Inquiry into the Territory Plan and other associated documents

**Submission Number:** 023

## Forrest Section 19 and District Strategies 2023 Volume Two District Strategies - comment

**RE: Draft Inner South District Strategy – Section 19 Forrest.**

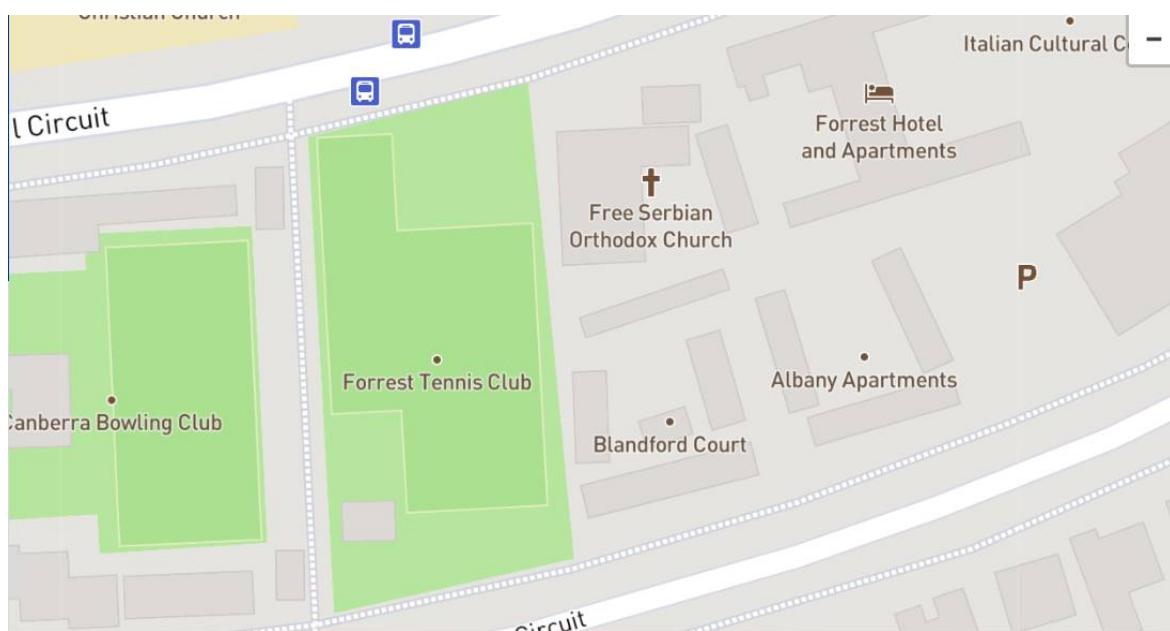
There is an existing walkway leading to the local school and two bus stops as shown in the Action bus map extract below. The publicly available pathway linkage connects National Circuit and Dominion Circuit (described as Block 10

Section 19) that lies between the Canberra Bowling Club and Forrest Tennis Club. This land is under the custodianship of City Presentation.

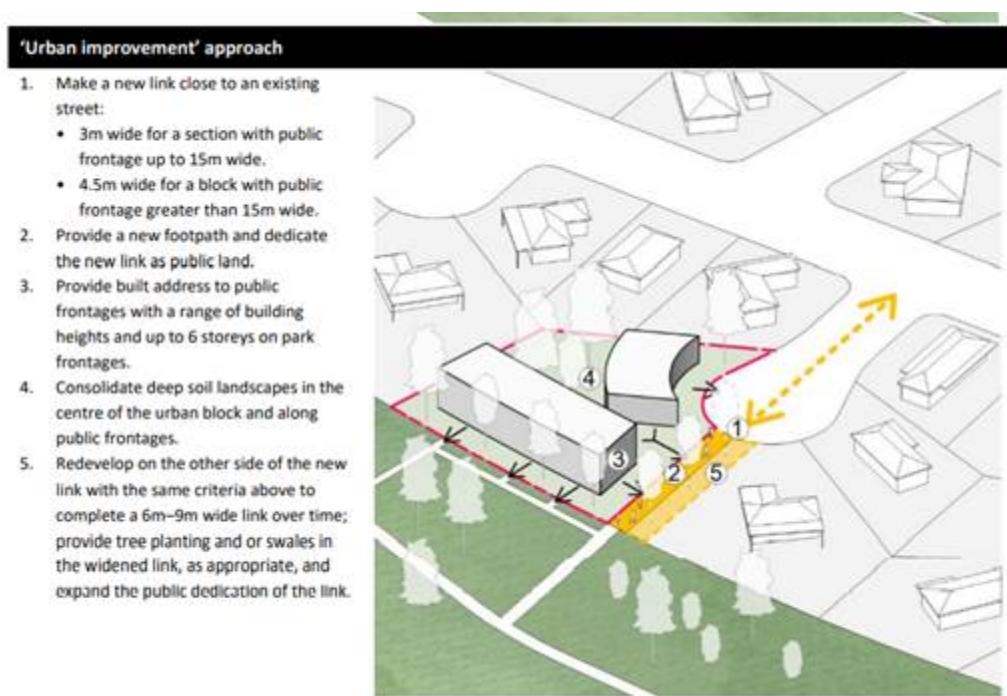
The distance between this existing walkway and Franklin Street to the east is 272 metres which exceeds the 180m desired by the strategy (as per the figure below and from page 140), however the proposed additional pedestrian connection does not connect to any existing transverse streets as shown in the Strategy illustration. Whereas the existing pathway connects pedestrians from Dominion Circuit and Arthur Circle to the school, the bus stops and the open oval opposite. We propose that Walter Burley Griffin got it right in their progressive refinements of their Canberra plan, and that the existing street and pathway arrangements around Section 19 neither discourage people from neighbourhood walking and offers sufficient useful connections to the public transport network.
